OPUHA WATER LTD

**Opuha Dam
Annual Dam Safety Inspection 2010**

Tonkin & Taylor Ltd

May 2010

Figure 3.4 Piezometer positions (note P2-5, P3-3 & P3-5 are decommissioned)

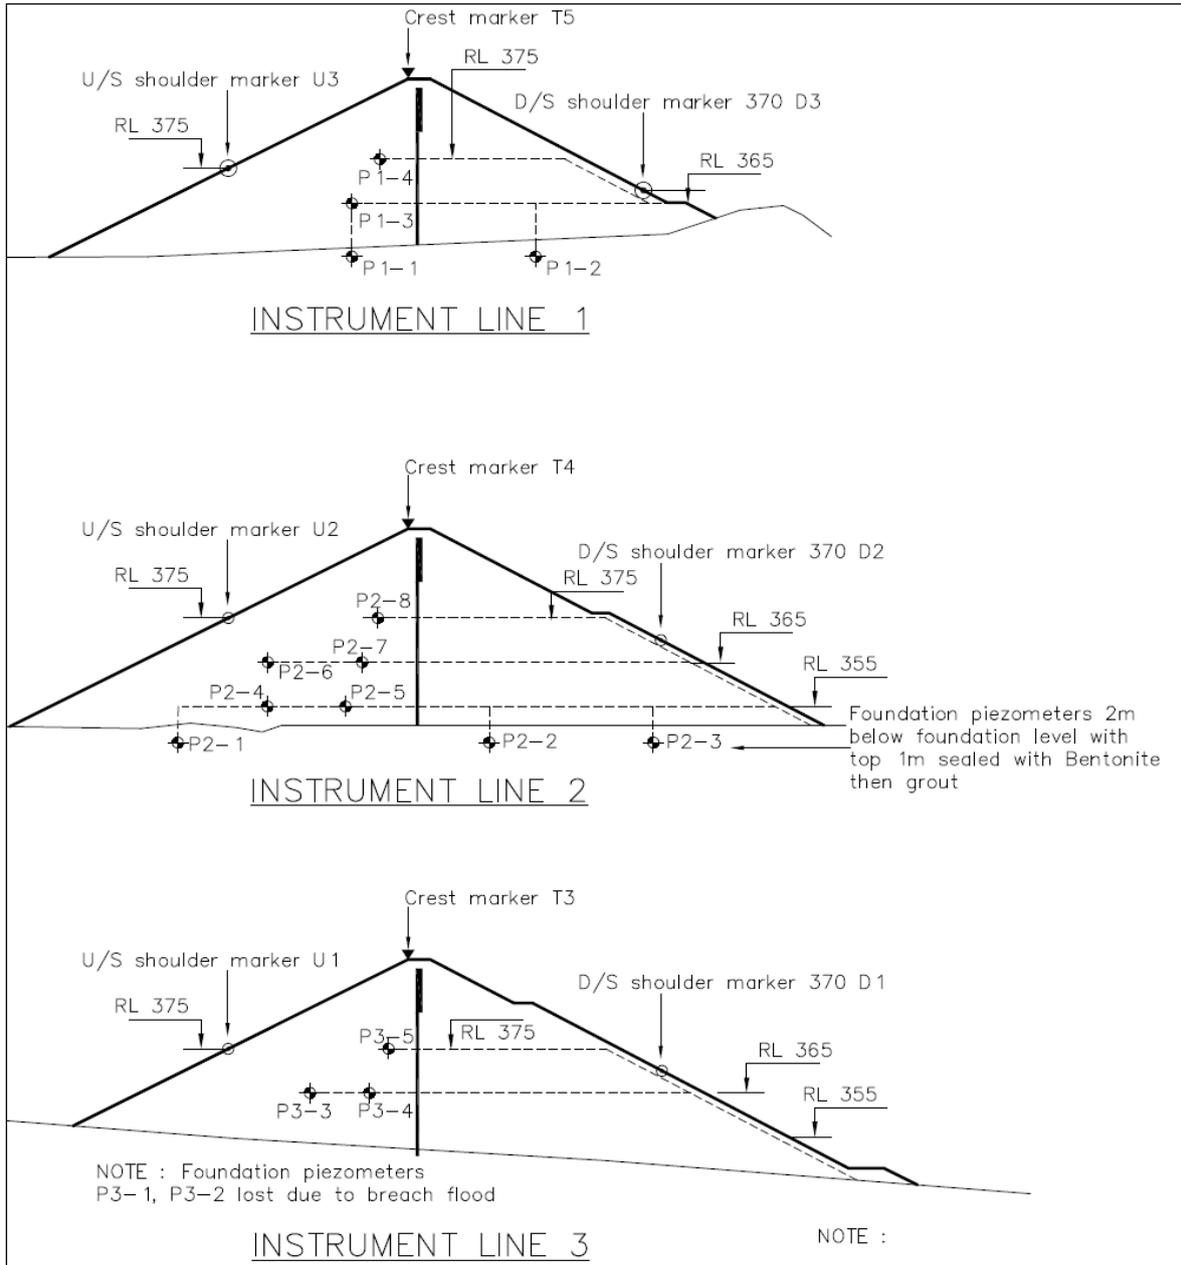
- Piezometers P2-5, P3-3 and P3-5 have been decommissioned because they are unresponsive. The readings are still recorded on site but are not reported.
- The gauges for piezometers P1-2, P1-3, P2-6, P2-7, P3-4, P1-4 and P2-8 were being repaired or replaced during early 2007 and readings were restarted on 8th August 2007.
- The remaining piezometers P1-1, P2-1, P2-4, P2-2 and P2-3 recommenced readings on 5th March 2007.

RCM2010-01: Complete a comprehensive review of the hydraulic piezometer system and identify necessary upgrade and maintenance works. For example: gauge calibration, consideration of a requirement for a control gauge, review of bladder and the like.
